RE: OCTOBER 2020 INDOOR AIR AND CRAWLSPACE AIR SAMPLING SUMMARY
REPORT REV01, SHOPPER'S FORUM MALL ANNEX, FAIRBANKS, ALASKA

DEC FILE NO. 102.38.100

We received comments from DEC for the first draft of this document on May 3, 2021. Our response to comments is included as an attachment.

Shopper's Forum Annex Fairbanks, Alaska	
SAMPLE LOCATIONS, BAMBOO PANDA	
July 2021	103777-001
 SHANNON & WILSON, INC. <small>GEOTECHNICAL AND ENVIRONMENTAL CONSULTANTS</small>	Figure 2

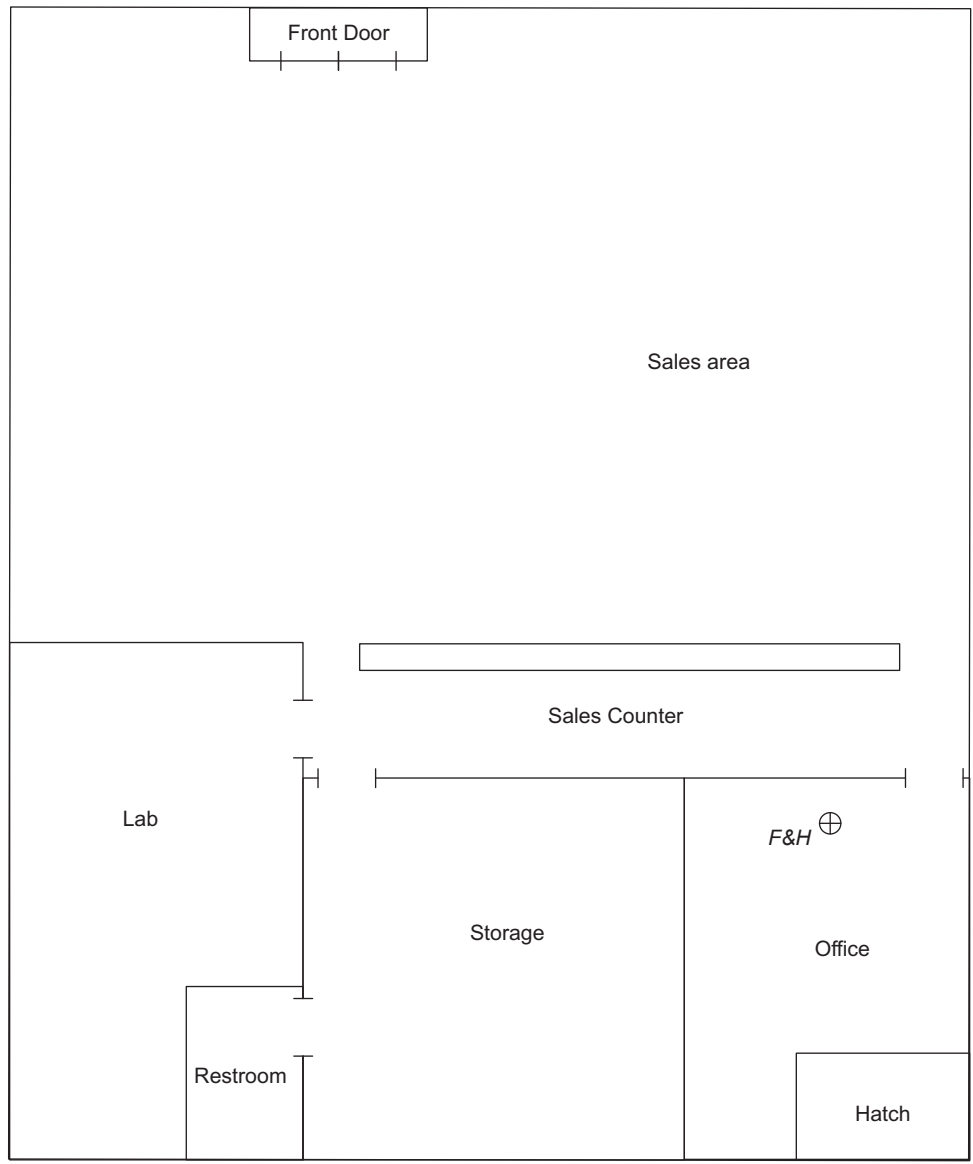
2.	ADEC has the general impression that the vapor barrier was discovered to be cut open sometime between the October sample event and the February walk through inspection. Please clarify.	The vapor barrier below Bamboo Panda was discovered on February 8, 2021 to be cut. Gavora maintenance staff do not regularly access that portion of the crawlspace, so it is unknown when the vapor barrier was damaged between the last time it was accessed (October 2020) and February 2021.
